THE ANNEX

APARTMENT COMMUNITY

SITE PLAN FOR PLANNING COMMISSION

Administrative Amendment Narrative

THE ANNEX
AMENDMENT FOR PLANNING COMMISSION
GRADING & SOIL EROSION CONTROL PLAN (SOUTH)

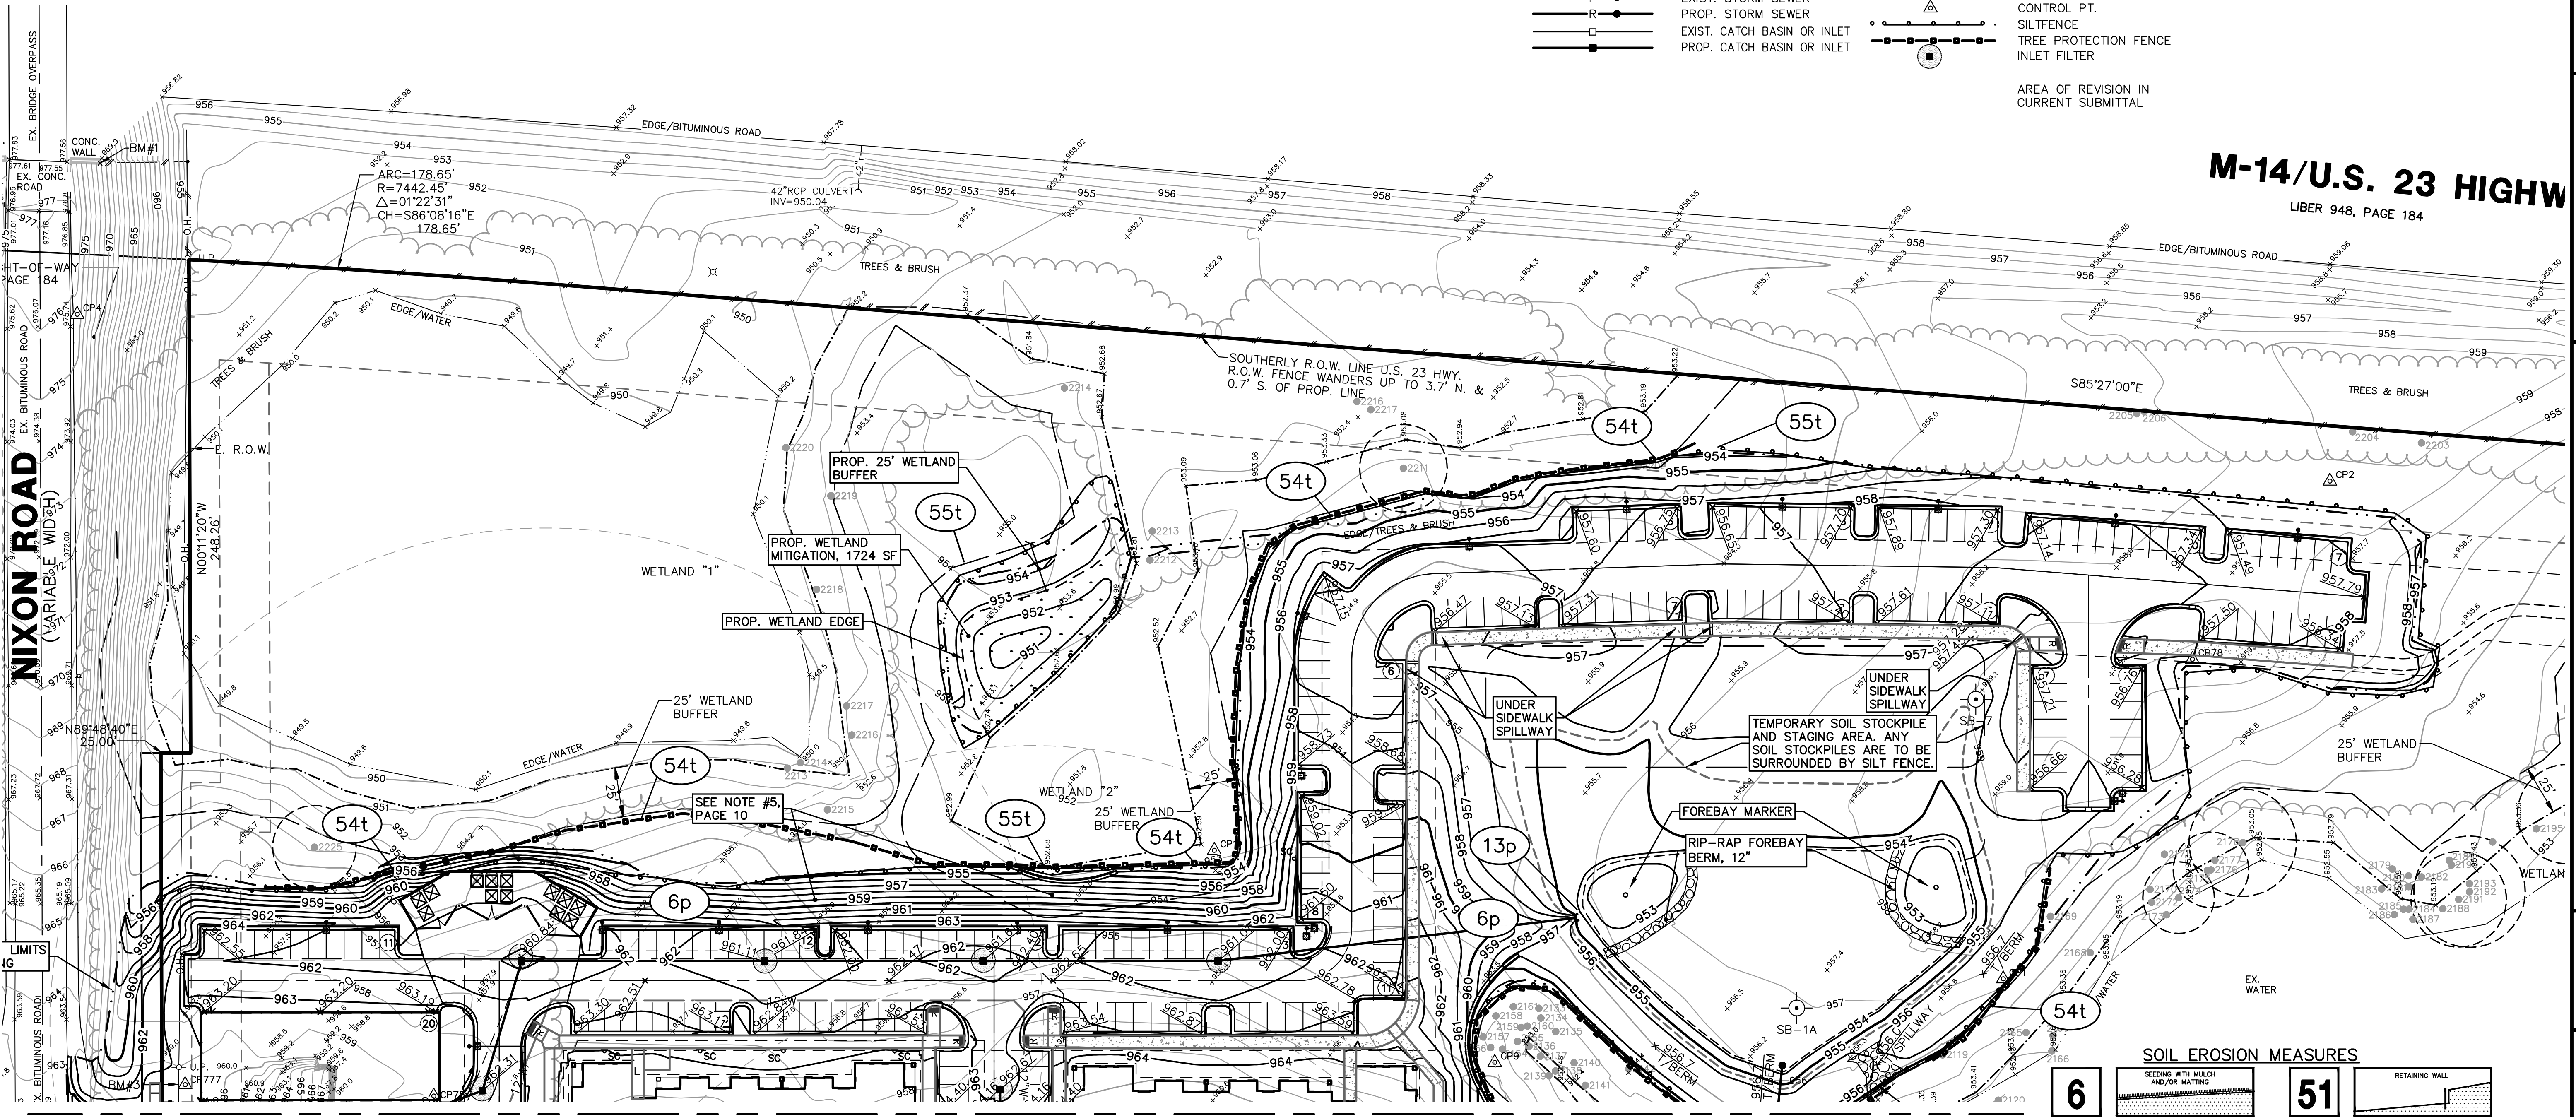
Sheets 8 & 9: Grading has been modified on the north parking areas since that building was eliminated. The north detention pond has been reshaped. The north parking areas have been designed to sheet flow to the detention pond.

THE ANNEX
AMENDMENT FOR PLANNING COMMISSION
PHASING AND PROJECT NARRATIVE

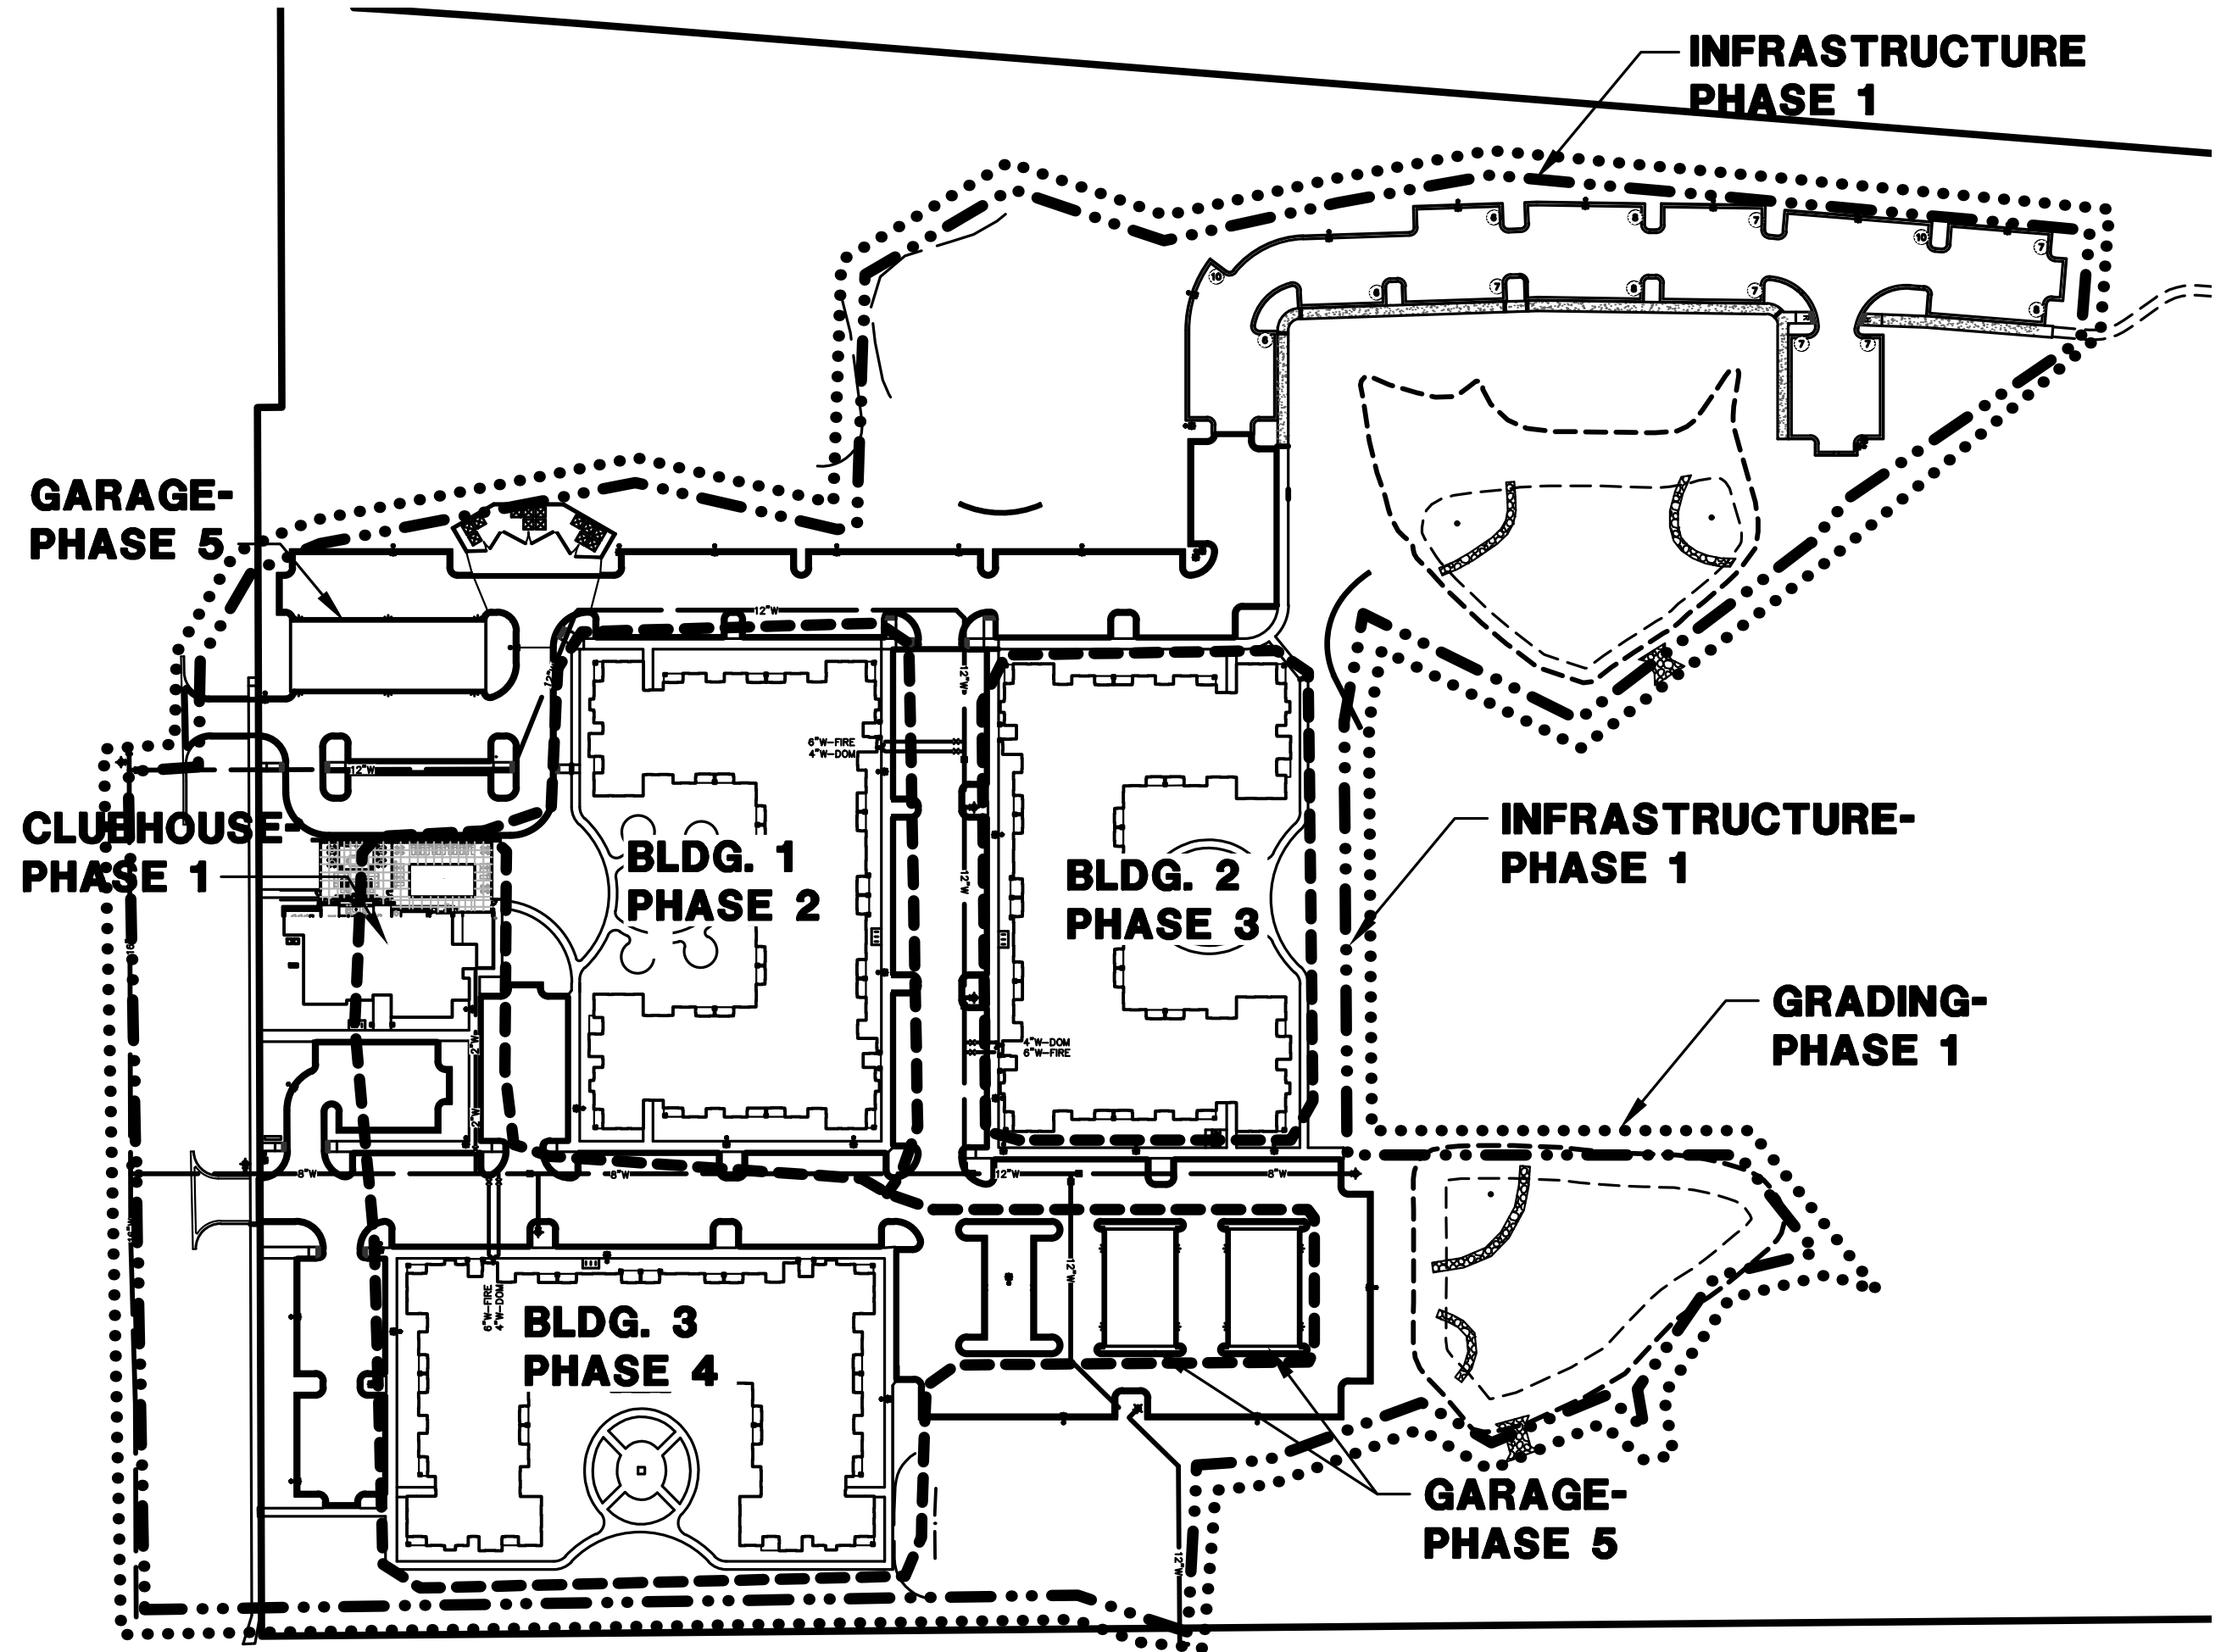
Sheet 12: Phasing limits have been reconfigured. Infrastructure will be constructed in the first phase and each building will be constructed as a separate phase.

THE ANNEX
AMENDMENT FOR PLANNING COMMISSION
LANDSCAPE PLAN (SOUTH)

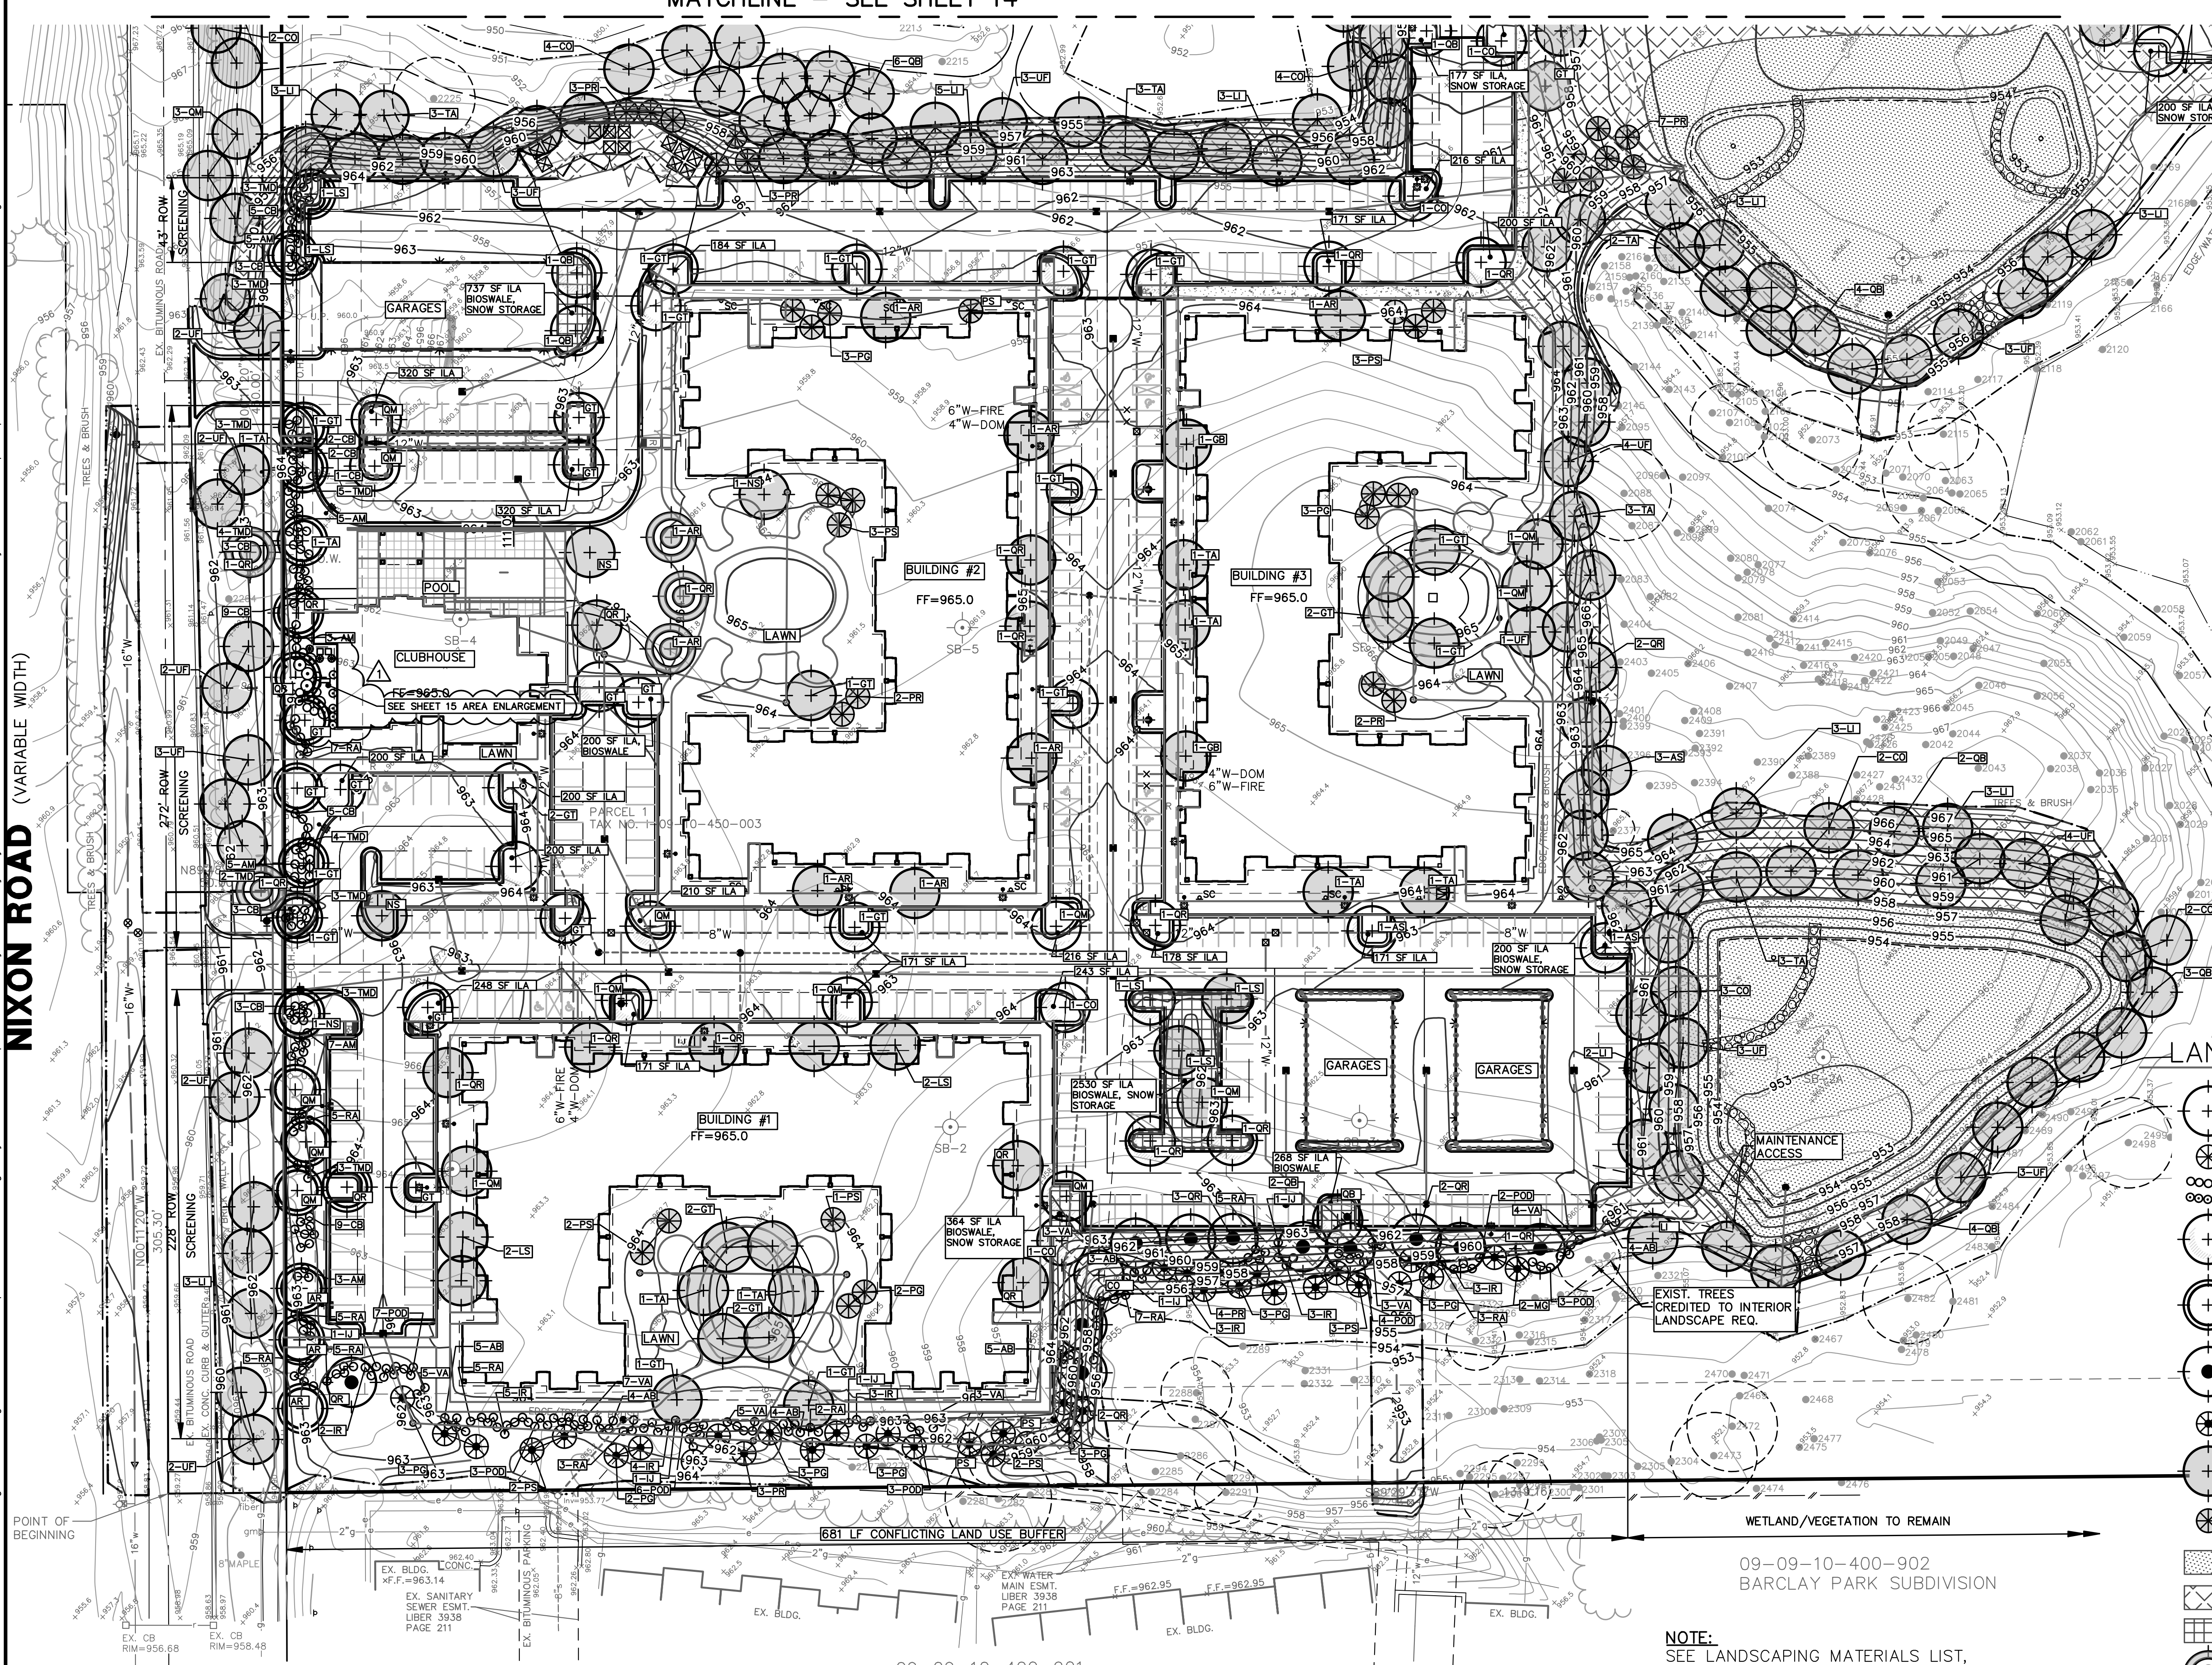
Sheet 13 & 14: The same number of proposed planting are shown. Some have been relocated around the north detention basin in the area of the building that was eliminated.

The Natural Features Protection plan has been revised. A landmark tree, tree #2270, a 17" white oak, along the Nixon Road frontage was removed during the construction process. This was done once the south entrance was placed, there was not adequate sight distance. It was removed for safety reasons. Mitigation in the form of tree replacement has been shown in this submittal at a 200% replacement, or 34" of replacement inches. This is accomplished with 14 - 2.5" caliper trees, 7 red maple and 7 red oak shown on sheets 13 and 14.
